Software Update Notification

PSS0023-07: Malvern Link v1.39 software

RTSizer Error. Timeout before starting the action on alarm

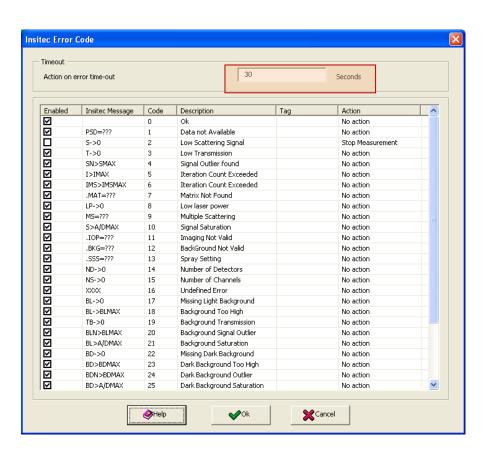
After a measurement error, the action on is automatically started. The new option defines a buffer time before starting the action.

Process Control Variables error

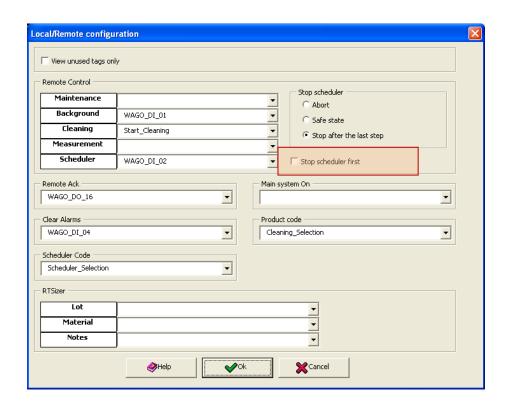
If a background is requested during a scheduler, a new option has been added to stop the scheduler first before performing the background

Automatic Clear Alarms option

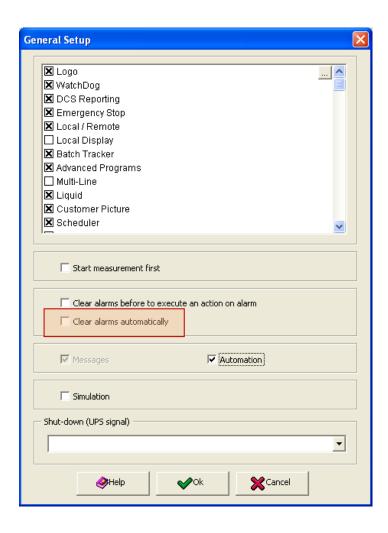
The new options allows emptying the alarm list when there is no alarm active

New batch tracker error

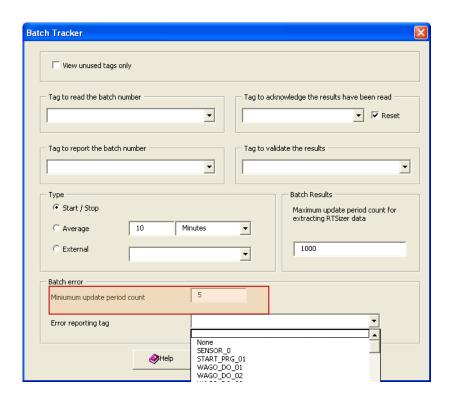
A new error has been added. The error is raised when the number of record in the batch results is below a threshold. The user has to define the threshold. If the value is 0 the error will never be seen.

At-Line Vibration Feeder Adjustment

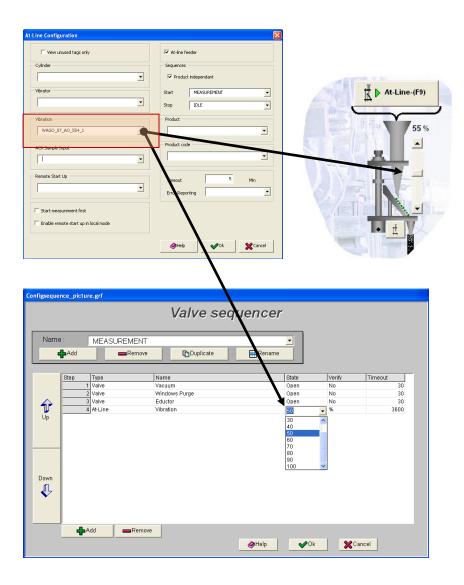
A new tag has been added to the At-Line option. The tag allows vibration feeder adjustment.

Clicking on the button Start/Stop vibration on the mimic will set the vibration to 0 for stopping or set the vibration to the previous value for starting the vibration
